Subject: Chiquita Lock Removal

I have reviewed the Chiquita Lock Removal Permit Application. I object to the Permit being issued as submitted, and I have attached copies of the relevant pages with my critical comments noted in red.

Roger Wood, President Greater Pine Island Civic Association, Architect Retired, Saint James City, FL

Figure 2. Aerial view of the Chiquita Boat Lock provided by Google Earth.

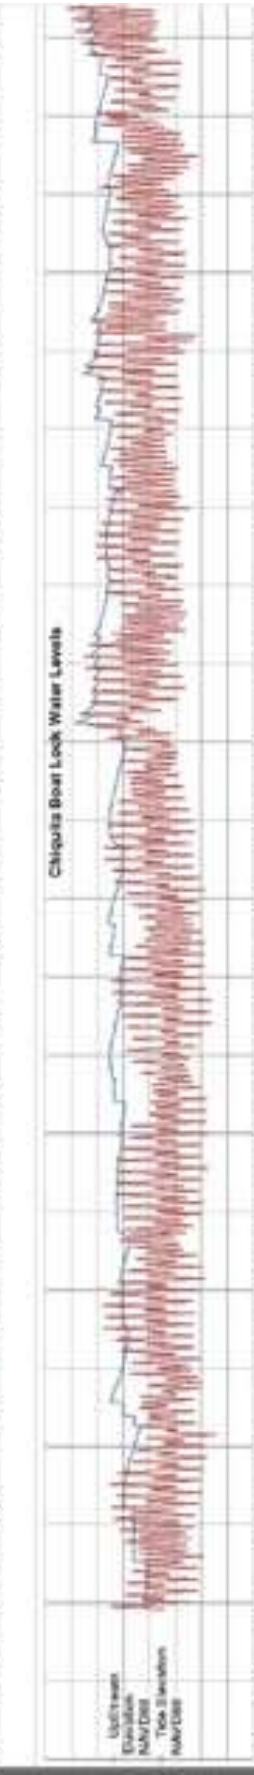
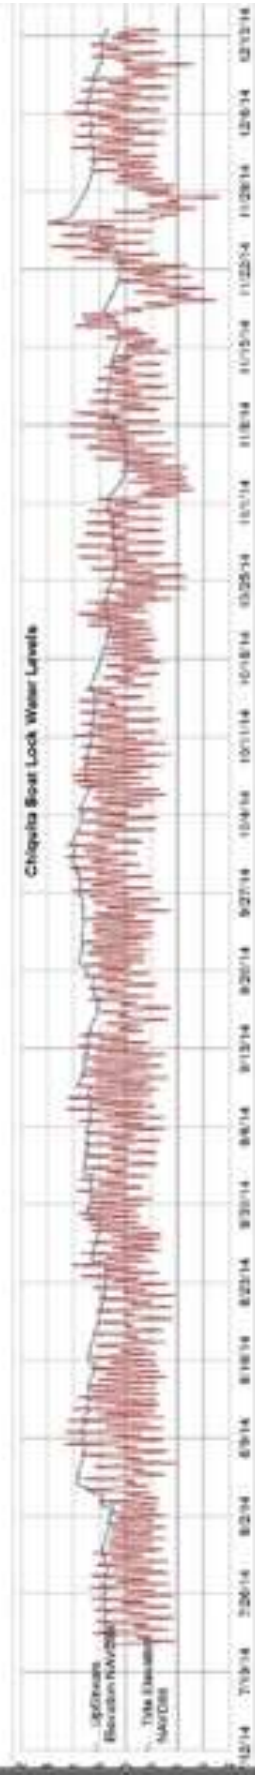
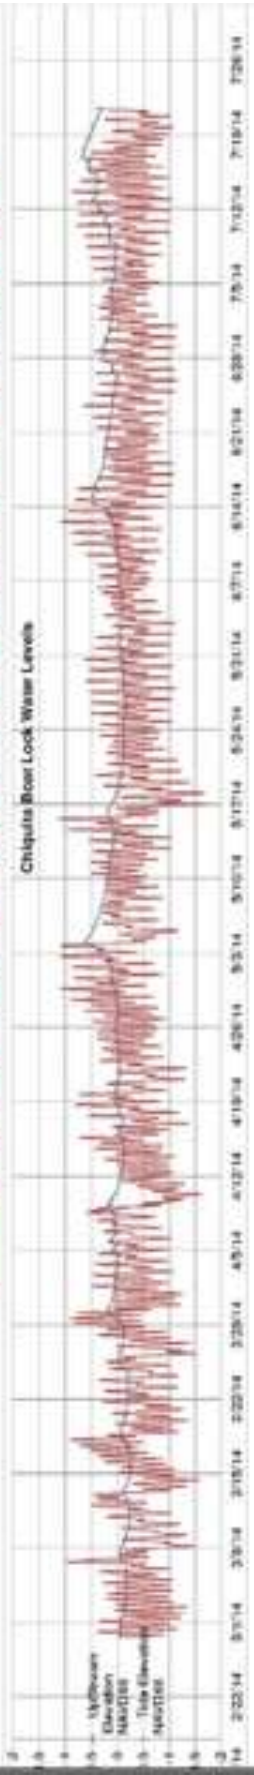
The "Purpose" of the Lock and South Waterway System is highlighted in yellow on the copy of Page 56 of the Lock Removal Permit Application shown below.

1. Stormwater was to be **RETAINED** in the Canals to settle out sediment and pollutants.
2. Flash Stormwater Levels would **OVERFLOW** the West and South banks to filter and spread uniformly through the Mangrove Forest. **REMOVING THE LOCK STOPS THOSE 2 TREATMENTS.**
